ADA Curb Ramp New Construction Inspection Form (Parallel)

NW Timeric

23885.56

PARALLEL RAMP (PL)

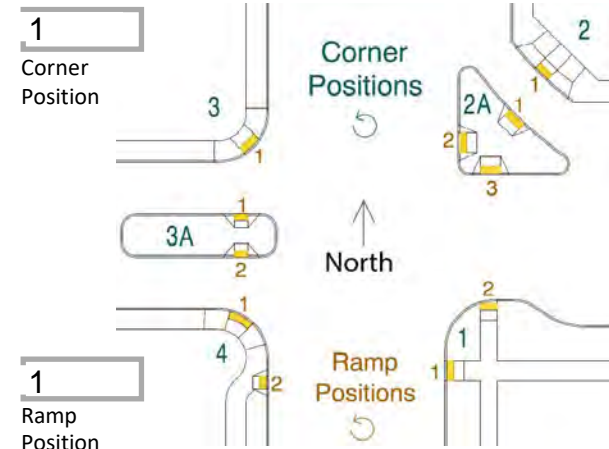
4.3 $\leq *$ ☐ $> *$ ☒

5.6 $\leq |5.0\%|$ ☐ $> |5.0\%|$ ☒

7.3 $\leq 2.0\%$ ☐ $> 2.0\%$ ☒

9.7 $\leq 2.0\%$ ☐ $> 2.0\%$ ☒

Comments:
NTD RR1 TS Fail
